**Cumberland County Subdivision and Land Development Review Report**

Municipality:	<u>New Cumberland</u>	Surveyor/ Engineer:	<u>Michael C. D'Angelo P.L.S.</u>	Owner/ Developer:	<u>Vincent and Susan Zvorsky</u>
Plat Title:	<u>Vincent and Susan Zvorsky</u>				
Plat Status:	<u>Final</u>	Plat Type:	<u>Subdivision</u>		
# of New Lots:	<u>3</u>	# of New Dwelling Units:	<u>0</u>	New Acreage Subdivided/Developed:	<u>0.1</u>
				Total Tract Acreage:	<u>0.34</u>
Zoning District:	<u>C-1</u>	Proposed Land Use:	<u>Mixed Use</u>		
Date Received:	<u>1/16/2020</u>	County Review:	<u>1/17/2020</u>	Reviewed by:	<u>SH</u>
				Checked by:	<u></u>

**FINAL MINOR SUBDIVISION PLAN  
 EXISTING CONDITIONS**

**VINCENT L. & SUSAN V. ZVORSKY**

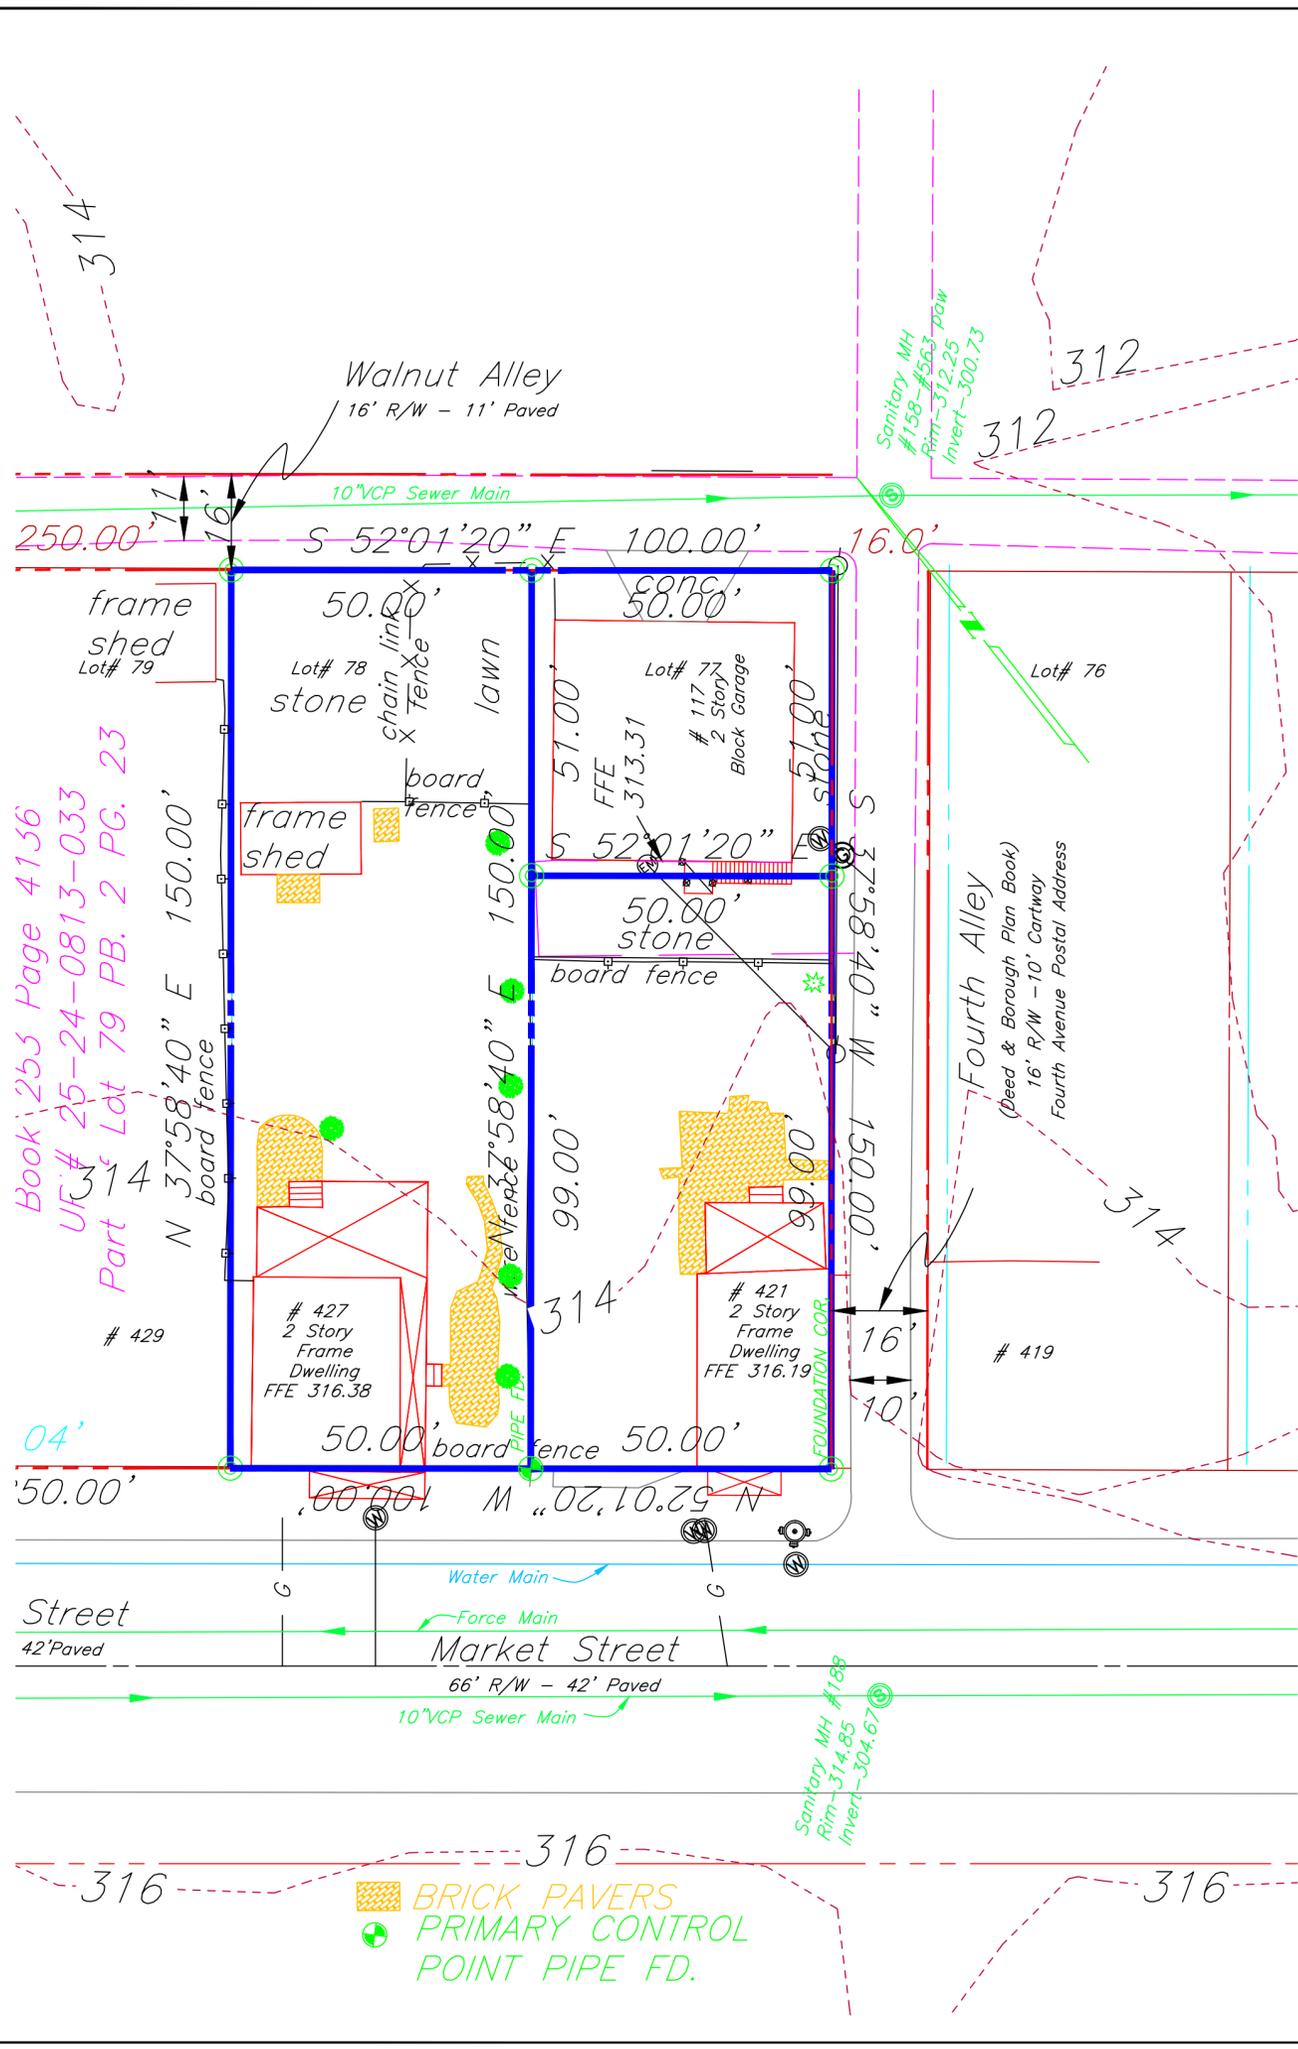
1. Borough may want to verify that the relocated frame shed will comply with the 5' rear setback requirement (Zoning 704).
2. The zoning ordinance information should be included on the plan. The information should include the district, the required and proposed dimensions, and proof of compliance with dimensions (Zoning 704 and SLDO 403.1.B.8).

3. Building setback lines should be shown on each lot involved in the subdivision (Zoning 704 and SLDO 407.1.A.13).
4. A minor subdivision plan should be accompanied by a written request to waive the requirements of a preliminary plan (SLDO 403). The plan should include a statement of the waiver and a date of the decision.

5. The plan should indicate the area of the Lot 1 and Lot 2 that is being transferred to Lot #3 (SLDO 403.1.B.6).
6. The Location Map should clearly indicate the location of the proposed subdivision (SLDO 407.1.A.10).

7. The purpose statement found in the General Notes should clarify the intent of the plan. Recommend adding the area of land being transferred and the lot numbers to the purpose statement.
